Enough is Enough

a report submitted by the
Canadian Coalition for Nuclear Responsibility
to the
Canadian Nuclear Safety Commission

regarding OPG's requested
authorization for the
Proposed Pickering B Refurbishment

August 12 2026

Fig. 4. Radioactivity in the environment from different elements, for an unmitigated SBO severe accident.

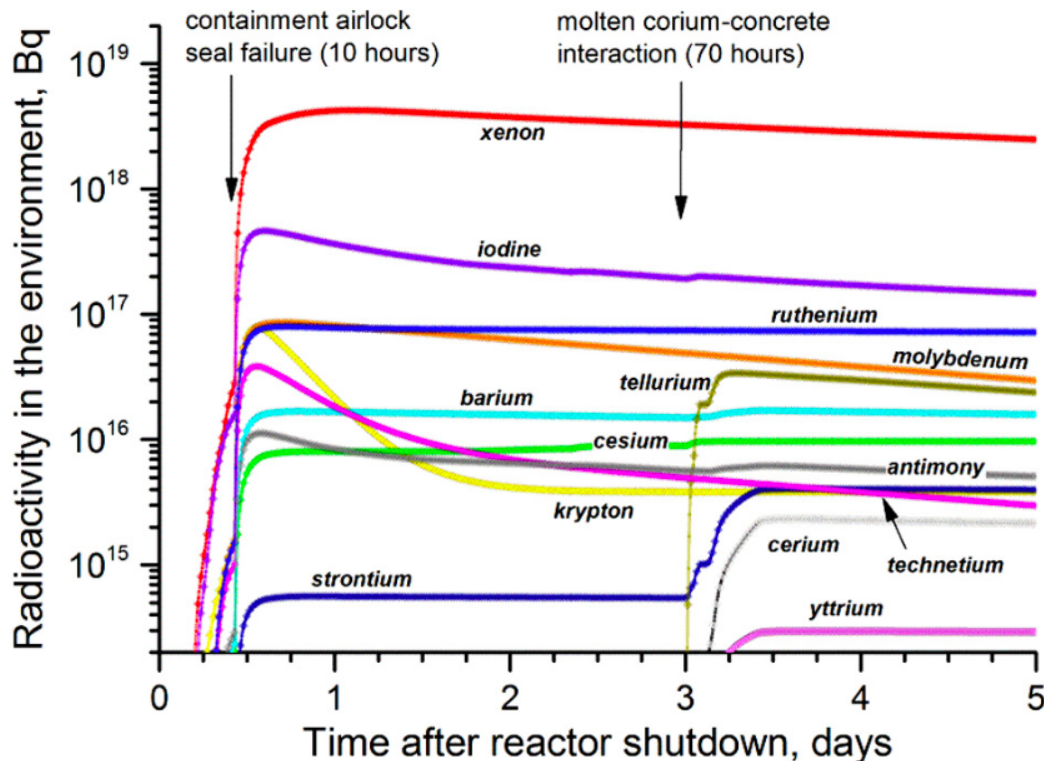
Below is a graph from a scientific research paper authored by four staff members from Canadian Nuclear Laboratories (CNL) and one from the Canadian Nuclear Safety Commission (CNSC). The graph indicates a radioactive release into the environment following a postulated CANDU nuclear accident – an unmitigated total station blackout.

The cesium-137 component (indicated in bright green) in this postulated release is at least 80 times greater than that proposed in the 2015 CNSC report. On the vertical scale, 10^{16} becquerels is equal to 10,000 terabecquerels; that is 100 times greater than the 100 terabecquerels indicated in the CNSC report cited above. Why the discrepancy?

The CNSC report asserts that no large release of cesium-137 can occur without “severe core damage”, described in CANDU literature as a “collapse of the core” or a “core disassembly” at temperatures near 1300°C or more. Since radioactivity cannot be shut off, heat continues to be generated even after fission is arrested. Overheating derives from a failure to remove radioactive decay heat fast enough. In the CANDU literature, this is thought to cause progressive collapse of many fuel channels inside the core, leaving damaged fuel bundles in a heap near the bottom of the calandria.

Recommendation 4: For the benefit of emergency planners, that CNSC provide a series of possible source terms for cesium-137 releases, following a severe nuclear accident, with 100 terabecquerels being the smallest entry. This will encourage first responders to envision and plan for a spectrum of different responses depending upon the severity of the release. Moreover, that CNSC staff publish proportionality documents indicating in each case the anticipated magnitudes of release of other radionuclides of public health or environmental importance.

Figure 1: Distances Between Header, the Liquid Relief Valves, the Degasser Condenser Safety Relief Valves and the Downstream Piping to Collection Tanks

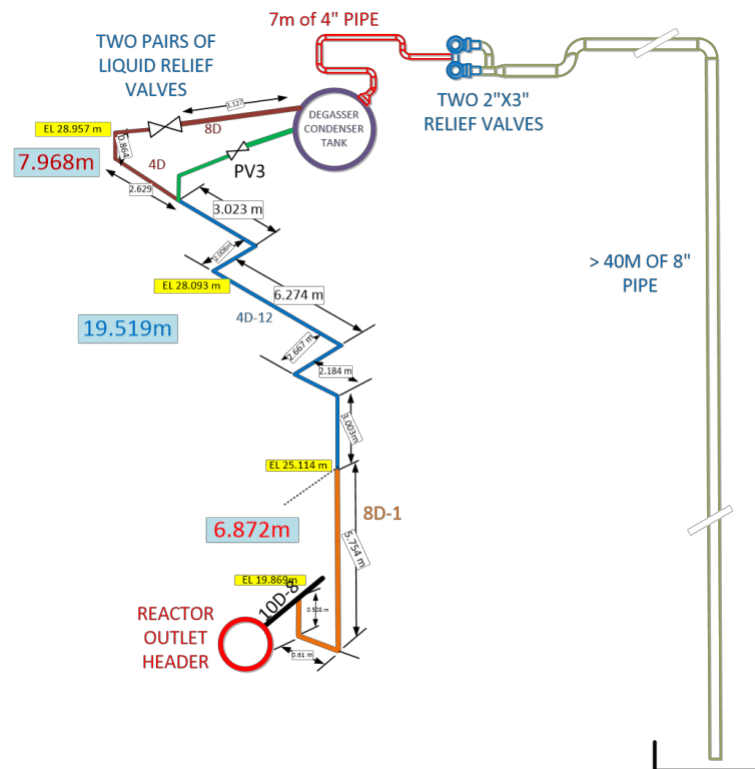
1. The safety relief valves downstream of the Degasser Condenser have a specified steam relief capacity of 4 kg/s. When tested, the actual relief capacity was lower than the specified relief capacity. For example, when tested in 2001 by OPG at Wylie Laboratories under the manufacturer Bopp & Reuther's supervision, the Pickering relief valve's combined steam relief capacity was 120 g/s for its two relief valves [11, 12]. The power of a single Darlington unit is 2776 MW_{th}, and the Bruce unit is 2832 MW_{th}, which is not too far from the Surry Nuclear Power plant. For Qinshan, the specified relieving capacity is of each valve is 26.66 kg/s at 268°C and 10.16 MPa(a).
2. The pressure relief valves in the operating stations in Canada are not close to the source of overpressure expected. As Figure 1 shows, they are several meters away from the headers.

3. The potential backpressure from the >40 m long piping downstream of the relief valves will significantly increase pressure. The pressure required to open the valves will exceed the pressure needed for the design.

After significant debate and analysis, the Working Group concludes that the relief capacity of the degasser condenser is inadequate for beyond design basis accidents such as a prolonged loss of all ac powers leading to a sustained loss of all heat sinks. It does not meet the current ASME and CSA's stated design requirements. A comparison with a similar Light Water Reactor system also points to the inadequacy for beyond design basis accidents. Post-Fukushima enhancements, including Emergency Mitigating Equipment and Containment Filtered Venting System, which have been added in Canadian nuclear power plants, provide countermeasures to stop the progression of severe accidents and minimize their radiological consequences to the public.
